No. 5879
H.P. Forest Department

Diversion of 0.8374 hac of forest land in favour of Rampur Hydro Electric Project, SJVNL Ltd. VPO Jhakri Tehsil Rampur Bushahr, Distt Shimla H.P. for the construction of river training road & road protection tec. within the jurisdiction of Rampur Forest Division, Distt Shimla H.P.

Memo;

Digital Map of Compensatory Afforestation Site Rampur Hydro Electric Project (412 MW)

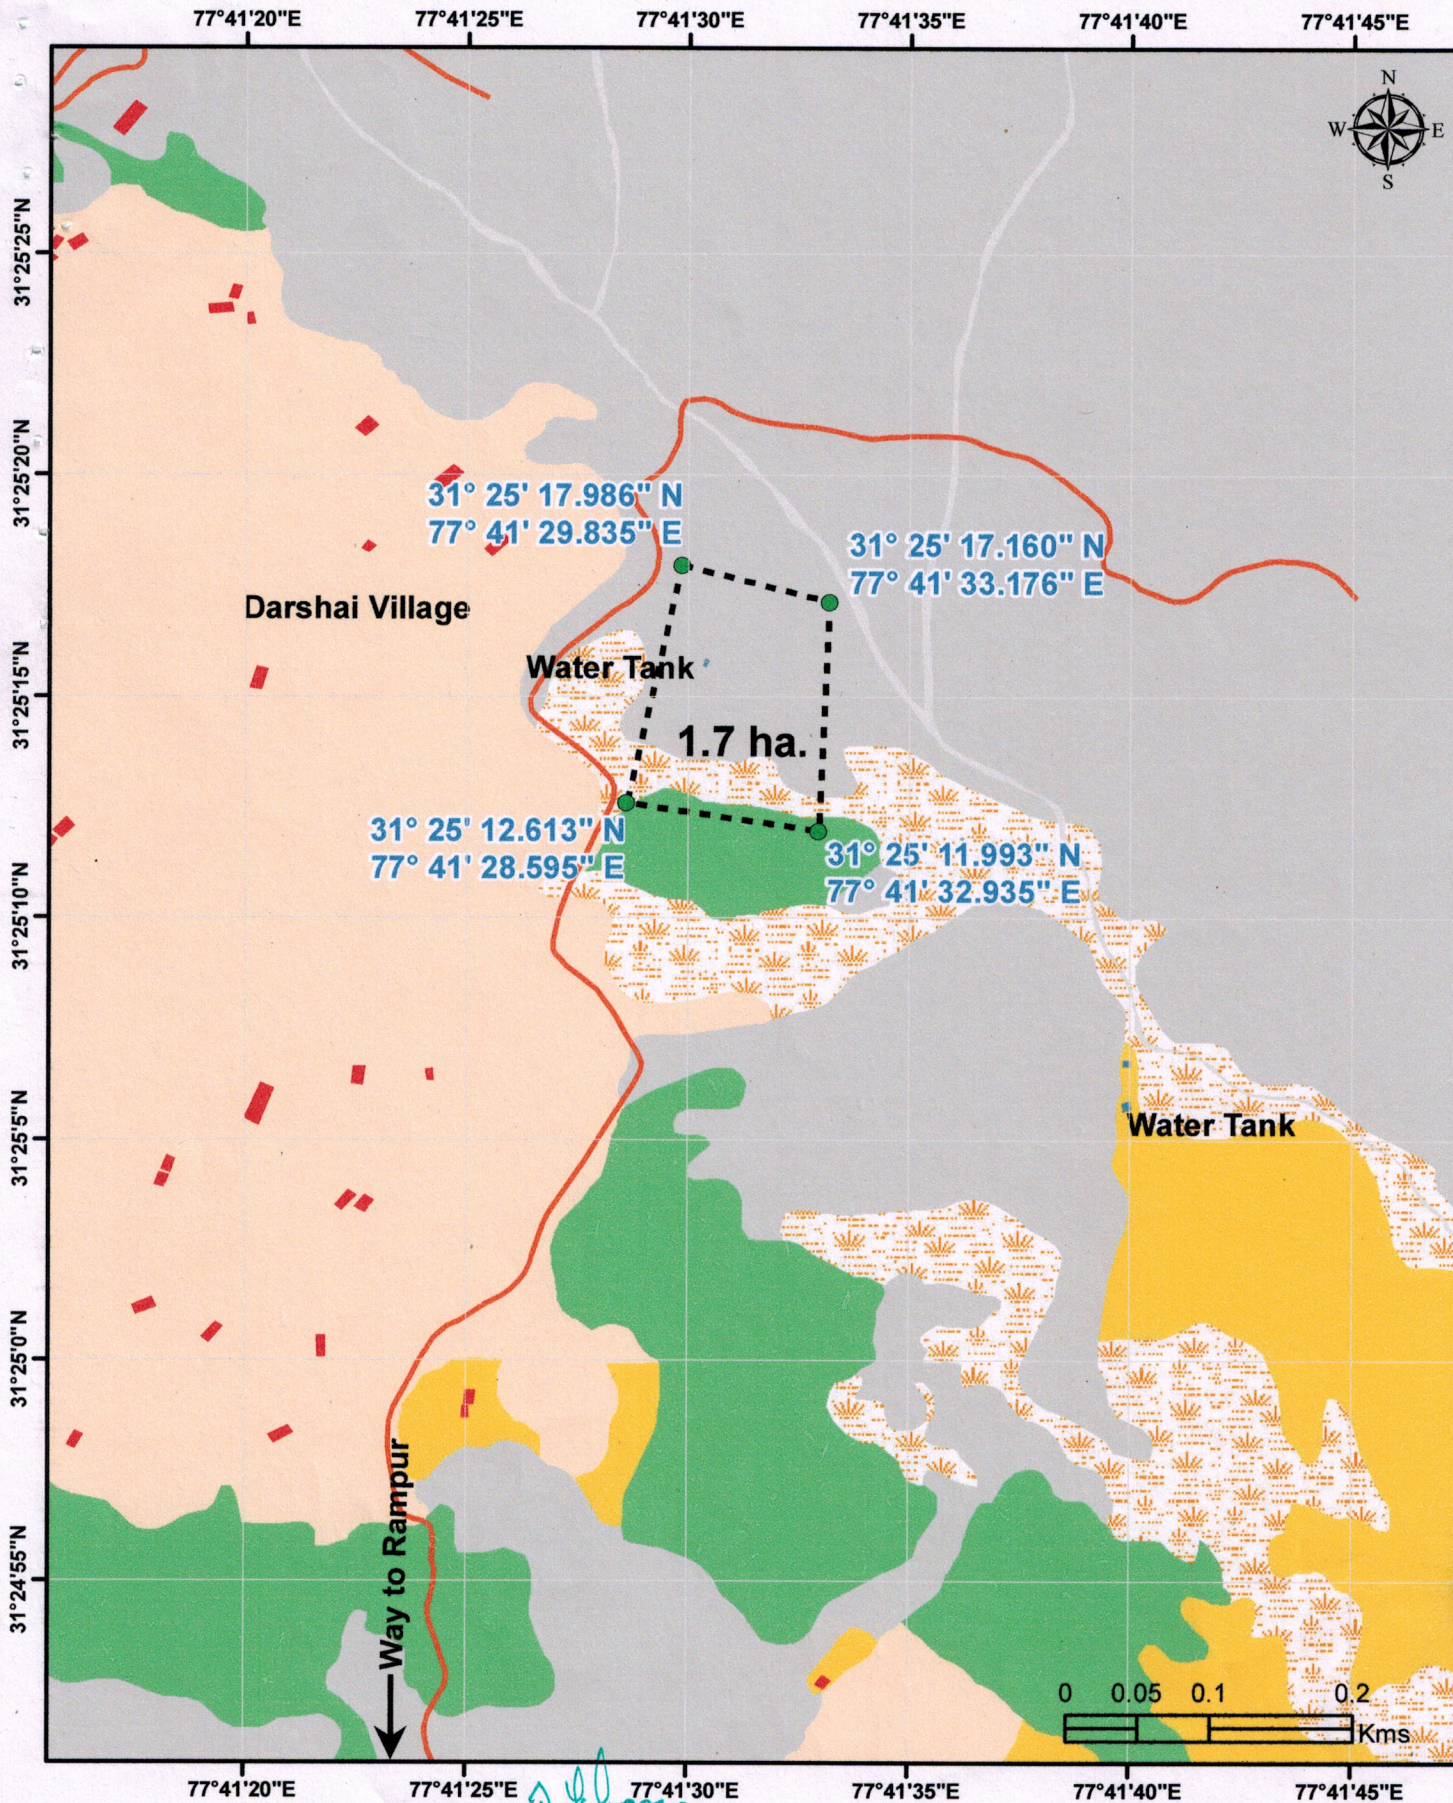
7.	CA scheme not uploaded properly and could not be opened. May uploaded again.	Needful has been done now.
8.	Digital map of area proposed for CA giving geo coordinates at minimum 4 points in hard and soft duly authenticated by DFO not provided.	Digital map of CA area authenticated by DFO enclosed as Annexure -3.
